VIRGINIA ELECTRIC AND POWER COMPANY
RICHMOND, VIRGINIA 23261

Serial No. 88-689E
NO/ETS:v1h
Docket Nos. 50-280
50-281
License Nos. DPR-32
DPR-37

VIRGINIA ELECTRIC AND POWER COMPANY
SURRY POWER STATION UNITS 1 AND 2
MAIN CONTROL ROOM AND EMERGENCY SWITCHGEAR ROOM
AIR CONDITIONING SYSTEM - PROPOSED
TECHNICAL SPECIFICATION CHANGE REQUEST

ATTACHMENT 1

FIGURE 1.1

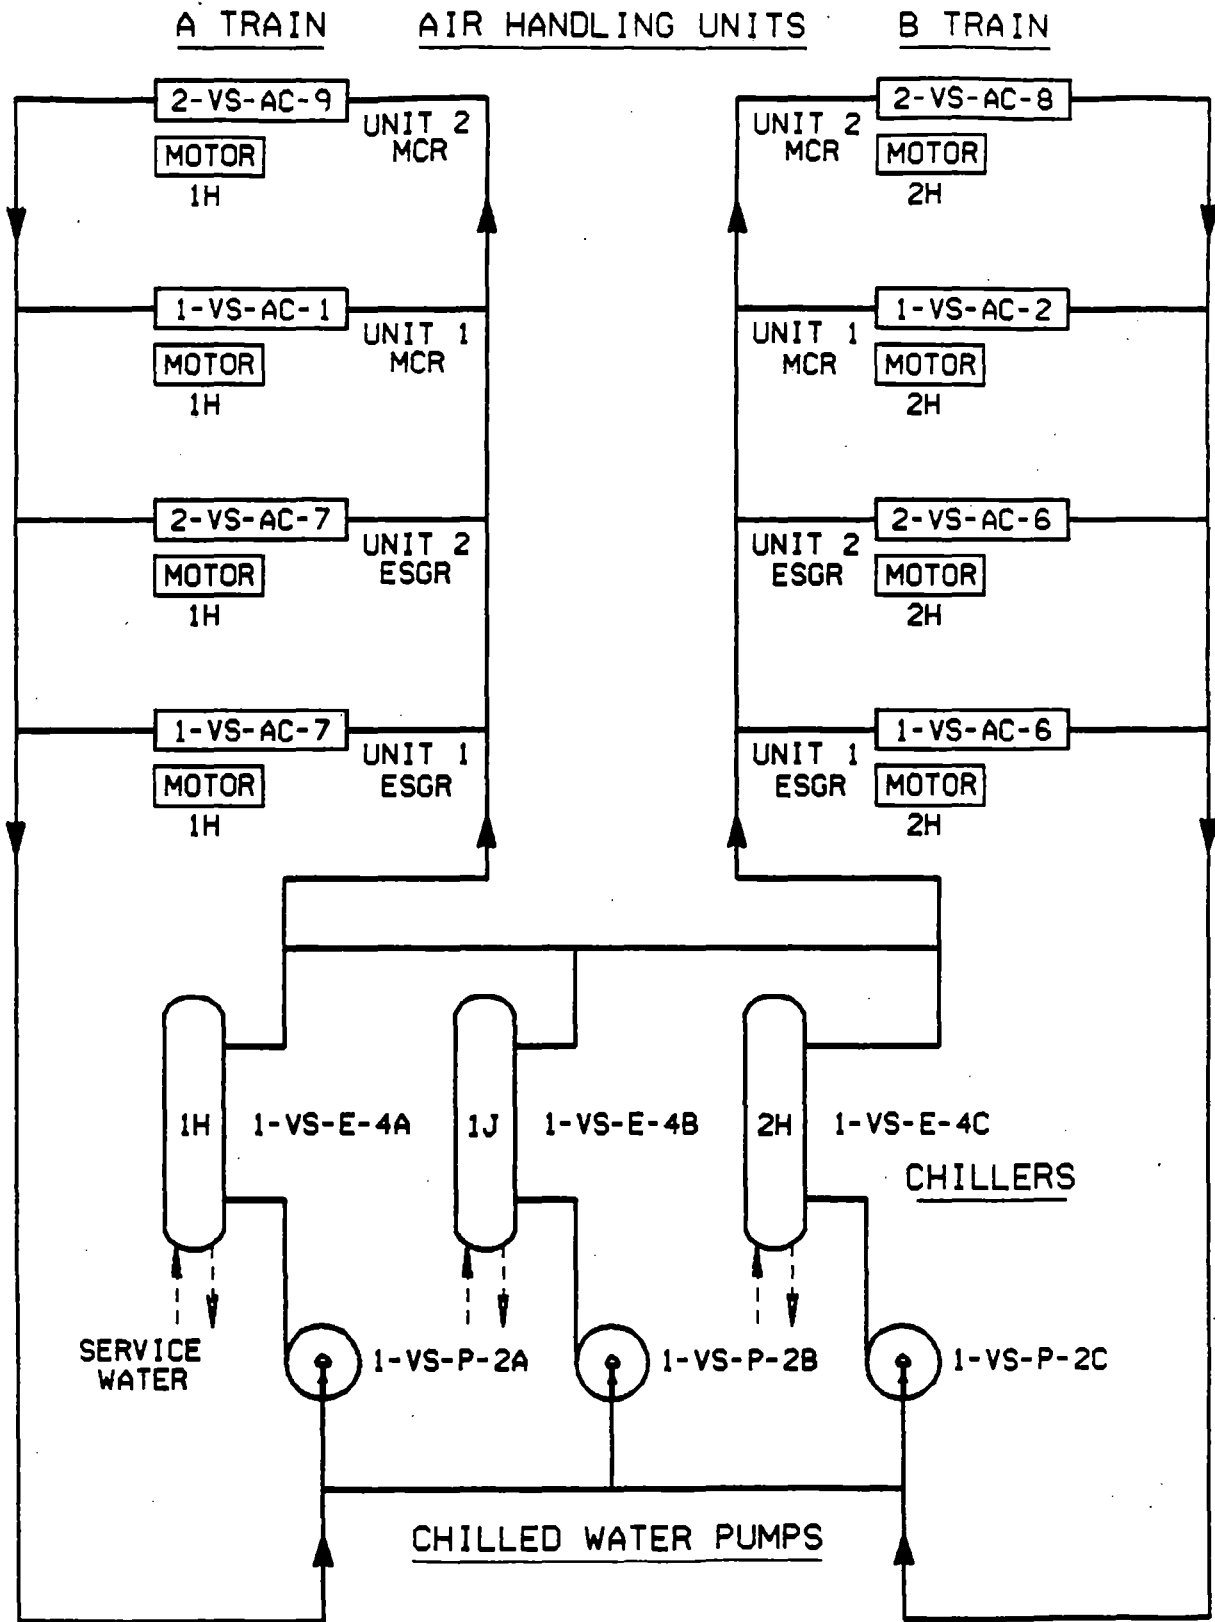
On September 9, 1988, a Station Deviation Report was issued to address the potential inadequacy of the MCR & ESGR Air Conditioning System to maintain these design room temperatures. The following discussion describes the approach used to assess this potential deficiency.

The data obtained from ST-220 was used to calculate a base case heat load, i.e. the heat load that existed at the time of test. The base case heat load was then extrapolated by calculation to arrive at design heat loads associated with normal operation and accident conditions. The results of this calculation substantiate that the design accident heat load (worst case heat loads due to the operation of equipment necessary to mitigate a LOCA) in the main control rooms is within the design capacity of a single train of MCR air handling units; therefore, it is concluded that the main control room portion of the MCR & ESGR Air Conditioning System is adequate to maintain design MCR temperatures. The calculation results also indicate that the design accident heat load in the emergency switchgear rooms exceed the design capacity of a single train of ESGR air handling units. A summary of the design heat loads as compared to the design capacity of the ESGR air handling units is presented in Table 2.1.

LER 88-033-0 was issued on December 2, 1988 to address these deficiencies. The deficiencies were attributed to 1) the cumulative effect of adding incremental heat loads to the emergency switchgear rooms, i.e. the installation of new electrical equipment over the years exceeded the system heat removal capacity and 2) the lack of adequate preventative maintenance and surveillance test programs.

FIGURE 3.1

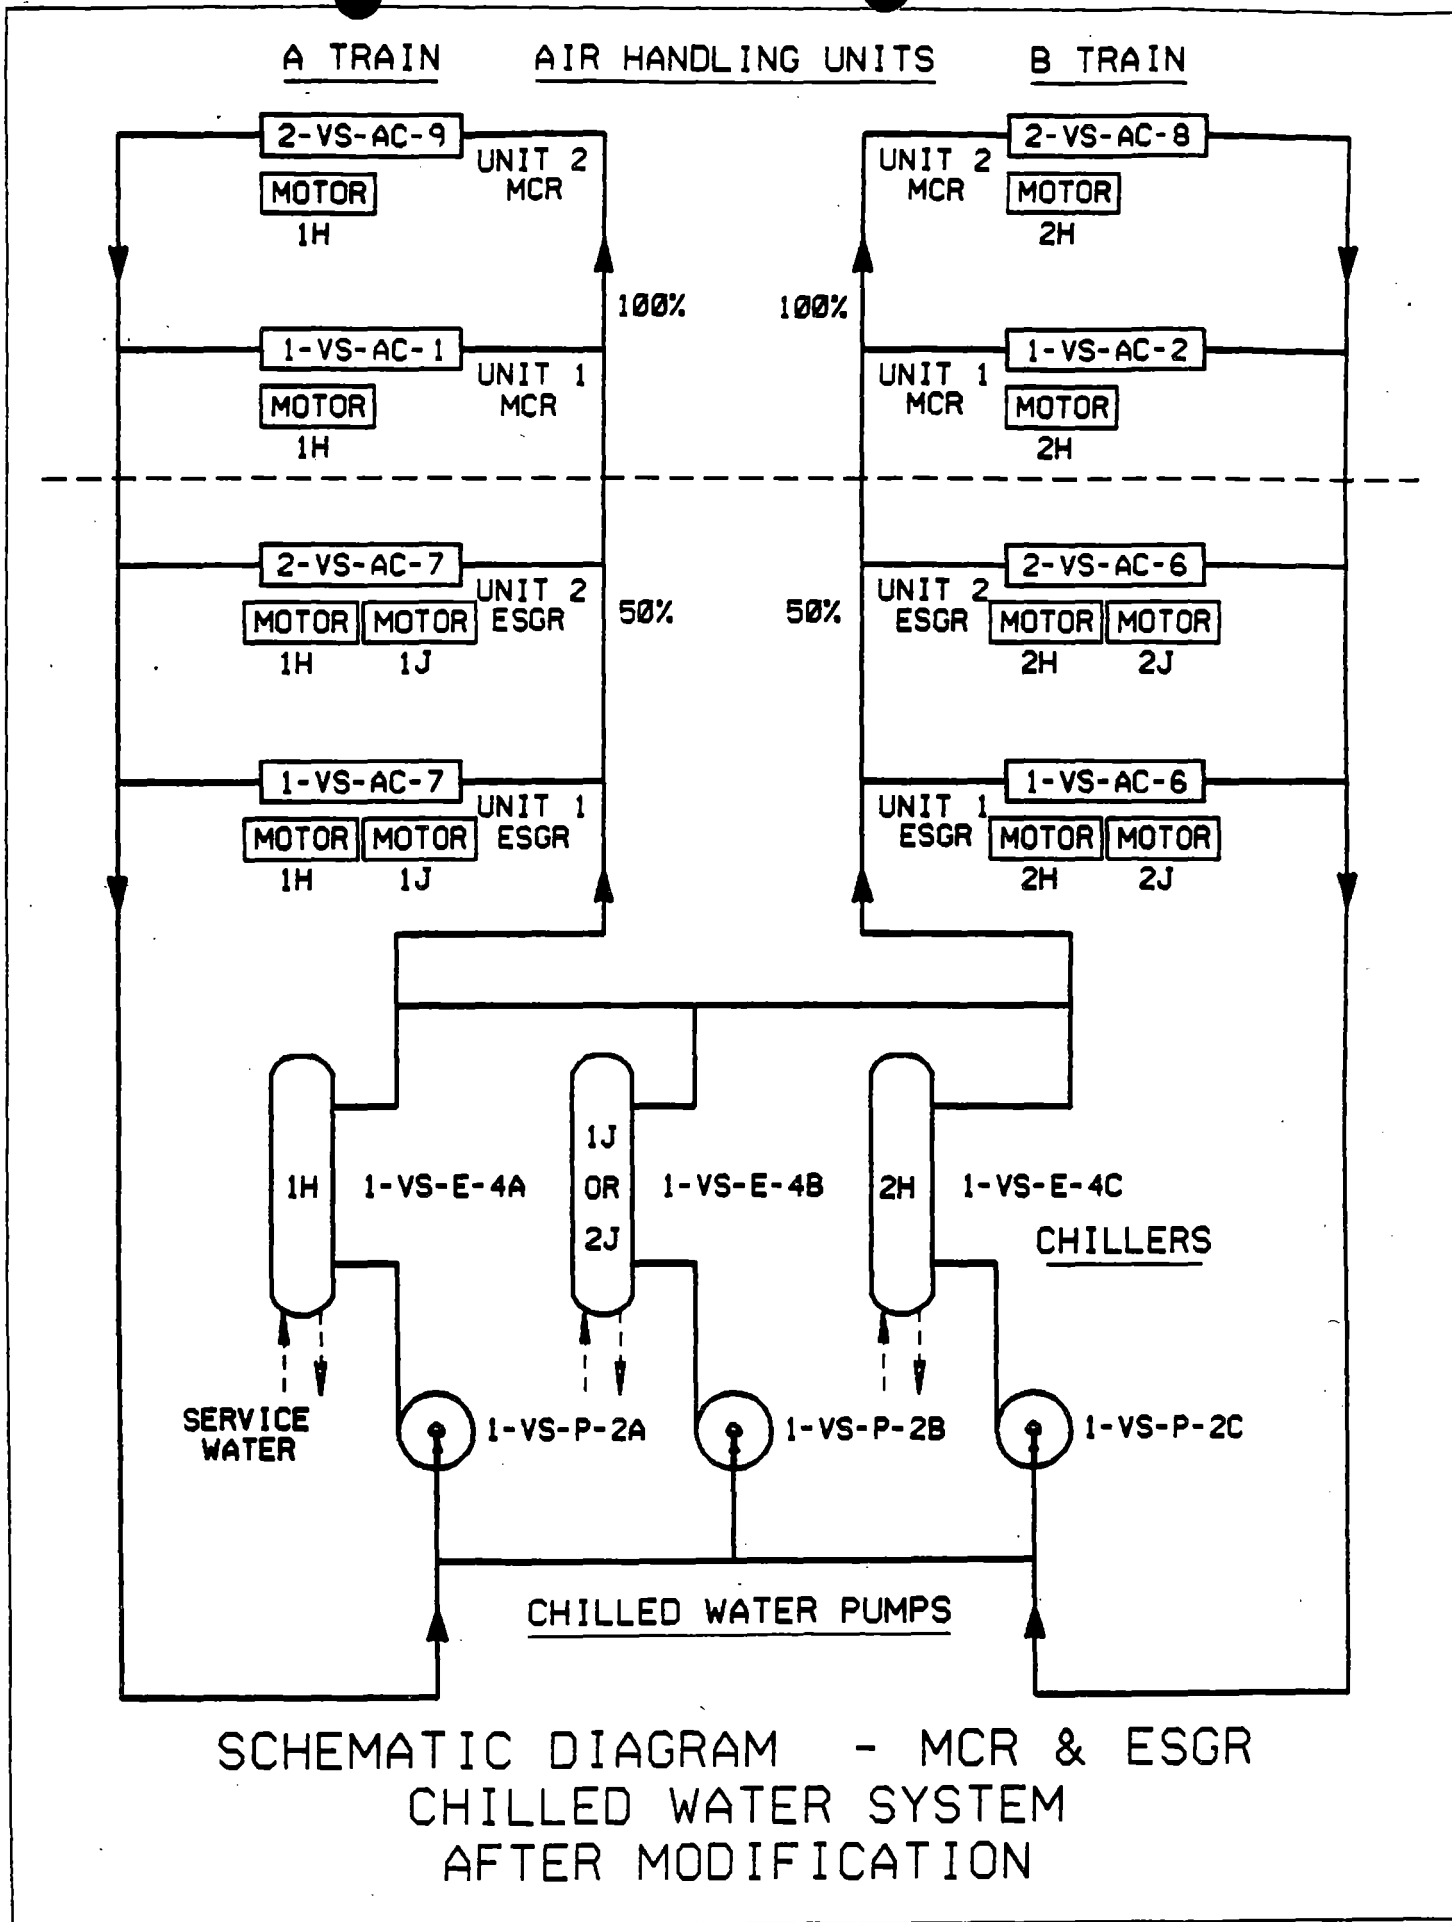
In the interim, the MCR & ESGR Air Conditioning System will be modified to utilize the existing equipment to meet the system design basis, i.e. maintain design room temperatures under design basis assumptions (LOCA, LOOP, Single Failure). Specifically, the interim system modification will require the operation of two air handling units in each emergency switchgear room and two chillers to maintain design ESGR temperatures under design heat load conditions. As indicated in Section 2.0, one operating air handling unit in each main control room is adequate to maintain the MCR design temperatures; therefore, no modifications to the MCR air handling units are necessary.

Modifications to the ESGR air handling units and chillers will be required to provide the necessary heat rejection capability and to maintain design basis assumptions. The ESGR air handling units must operate in parallel at higher total volumetric air flows to reject the maximum design heat loads. As such, the ESGR AHU fan speeds will be increased by approximately 100 RPM and minor duct modifications will be installed to prevent air velocities from exceeding duct design limits. The ESGR air handling units will also be modified to account for credible equipment failures. To ensure that operation of an ESGR air handling unit can be quickly restored in the event of drive motor or power source failure, a redundant drive motor will be installed on each ESGR air handling unit and will be powered from a different emergency power source than that of the primary drive motor. The modified arrangement is schematically shown in Figure 3.1. The redundant motor will be mounted on each air handling unit opposite the primary drive motor and will be

mechanically coupled to the shaft by sheave and belt arrangement. The redundant drive motor control switch will be mounted local to the equipment and will be appropriately labeled. The ESGR air handling units' motorized inlet air dampers and chilled water temperature control valves will be decoupled from their operators and locked in the full open position to ensure full capacity AHU operation and to remove them from active failure consideration.

A chiller modification will also be necessary to account for credible equipment failure. Because only two of the three existing chillers are required to operate under maximum design heat loads, modifications to the chillers are less extensive than those for the ESGR air handling units. However, in one of the failure scenarios considered for the existing design configuration, emergency power will be lost to two of the three chillers.

The Surry Power Station emergency electrical distribution system has a three emergency diesel generator (EDG) arrangement - EDG No. 1 powers the Unit 1 "H" bus (1H), EDG No. 2 powers the Unit 2 "H" bus (2H), and EDG No. 3 is a swing diesel and can be aligned to either the Unit 1 "J" bus (1J) or the Unit 2 "J" bus (2J). The failure scenario under discussion would involve a loss of offsite power and single failure of EDG No. 2 which would require that EDG No. 3 be aligned to the unit without power, i.e. to the Unit 2 "J" bus or 2J. Since chiller 1-VS-E-4B is powered from the 1J bus and chiller 1-VS-E-4C is powered from the 2H bus, both chillers would be without power. To accommodate this failure scenario, the interim modification will install a manual power transfer switch to enable chiller 1-VS-E-4B to be powered from either the 1J emergency bus or the 2J emergency bus. The transfer of power to the 1-VS-E-4B chiller includes the transfer of power to the necessary chiller auxiliary equipment, e.g. chilled water pump, chilled water MOV, and chiller condenser service water pump. No other modifications to the chillers are necessary.

The remaining credible failure scenarios which are accounted for by the interim modification design are summarized in Table 4.1. This table also indicates the corresponding action(s) which are required to restore equipment operability and the system margin pertaining to each failure scenario. The system margin qualitatively illustrates the difference between system capacity (which does not change) and heat loads which are inherently reduced as a result of certain failure scenarios. For example, loss of an emergency bus also results in the loss of associated heat producing electrical equipment. (NOTE: It would be helpful to refer to Figure 3.1 during review of Table 4.1).
